# Building Permit Application

Permit No.: **B14000567**

| Existing Use: <b>SINGLE FAMILY DWELLING</b><br>Proposed Use: <b>16x32 MASTER BEDROOM ADDITION</b><br>Estimated Construction Cost: <b>\$80,000 - 512 sq ft</b><br>Description of Work: <b>ADDITION WITH BATHROOM, BEDROOM AND LAUNDRY ROOM UNFINISHED BASEMENT. RENOVATE EXISTING KITCHEN</b><br>Occupant or Tenant: <b>SAME AS OWNER 16x32</b><br>Was tenant space previously occupied? <input type="checkbox"/> Yes <input type="checkbox"/> No<br>Contact Name: _____<br>Address: _____<br>City: _____ State: _____ Zip Code: _____<br>Phone: _____ Fax: _____<br>Email: _____ |  | Applicant's Name & Mailing Address, (if other than stated herein)<br>Applicant's Name: <b>SAME AS CONTRACTOR</b><br>Address: _____<br>City: _____ State: _____ Zip Code: _____<br>Phone: _____ Fax: _____<br>Email: _____   |  |

RE: **Building Permit # B14000567**

FLOOR PLANS

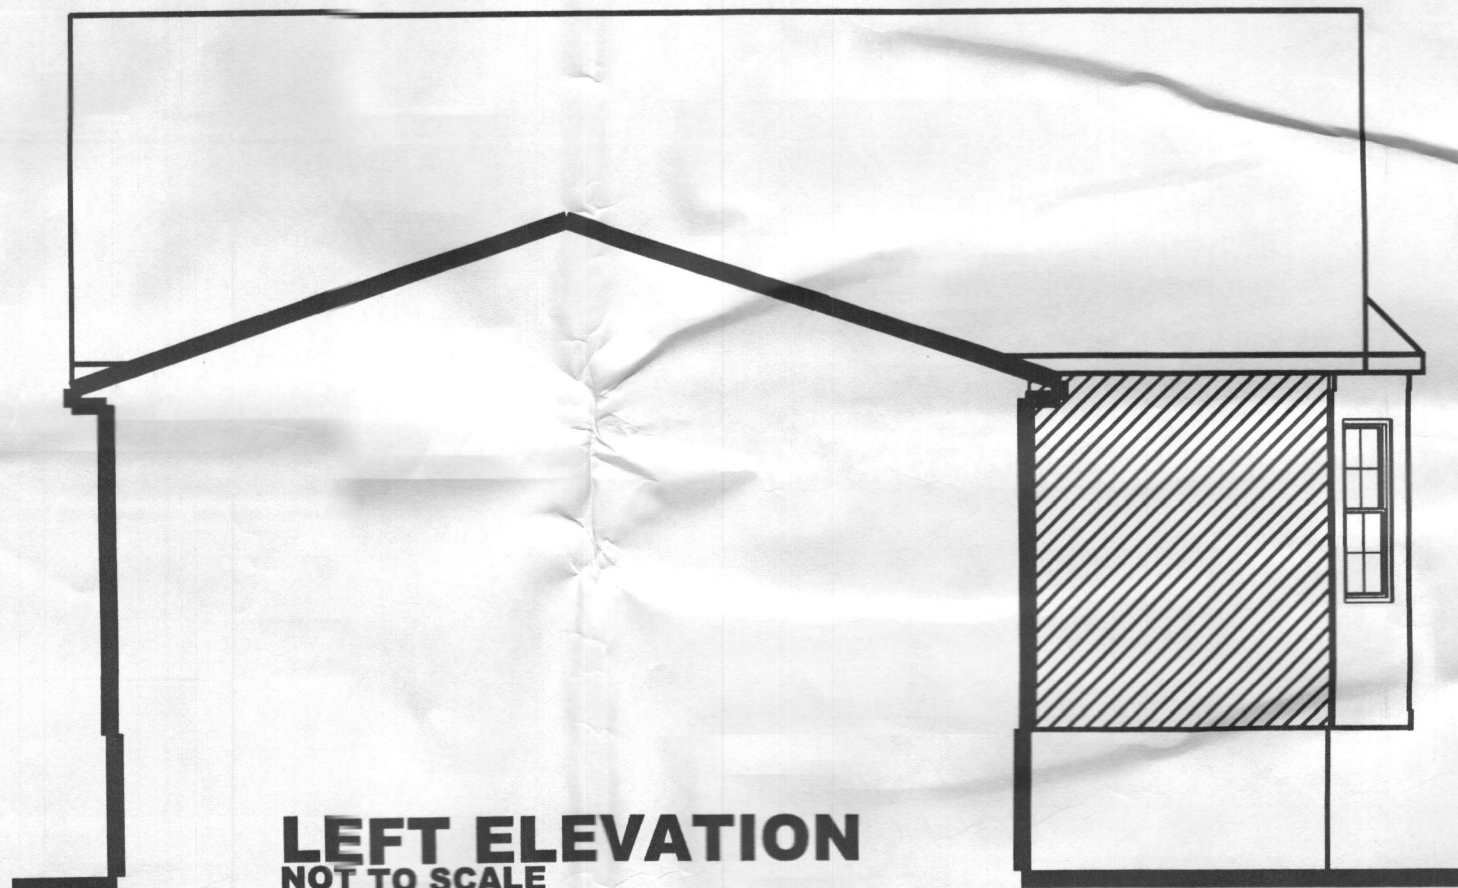
Further review is contingent upon submission of a revised building plan showing the following:

- Floor plans for the existing house and proposed addition.
- Plan must be to scale with septic system and all of its components shown on plan.
- Your septic system may have to be upgraded to accommodate the new addition and that decision will be based on the final review of the floor plans and the current septic system conditions.
- As of January 1, 2013, all new construction is required to use the "Best Available Technology" (BAT) for septic installation. Before building permit approval, a BAT site plan must be submitted along with your building application and building plan.

I have received floor plan for the proposed addition and other supporting documents. Your floor plans reflect **4 bedrooms** and your current septic system cannot support your proposed addition. Our records indicate that your file is incomplete and we will have to do percolation testing to establish a 10,000 square foot septic system. In addition to percolation testing, a percolation certification plan will be required to process your building permit. A new 2000 gallon tank will also be required and based on the information you have presented, it appears as if you will fall into our category of the new laws implemented January 1, 2013. As of January 1, 2013 a person may not install or have installed an on-site sewage disposal system (OSDS) unless the OSDS utilizes Best Available Technology for any of the following reasons:

- \_\_\_\_ Letter of response to Howard County plan review code letter
- ☒ Revised plans and/or revised details: When submitting for a complete re-review, duplicate sets shall be submitted.  
*Per health - revised to show a study - not a bedroom.*
- \_\_\_\_ Structural steel certification
- \_\_\_\_ Energy conservation calculations
- \_\_\_\_ Certification for \_\_\_\_\_ (be specific).
- \_\_\_\_ Copies of \_\_\_\_\_ (be specific).
- \_\_\_\_ Two sets of single family dwelling model plans to be placed on permanent file: Model name and/or # \_\_\_\_\_
- \_\_\_\_ Other \_\_\_\_\_
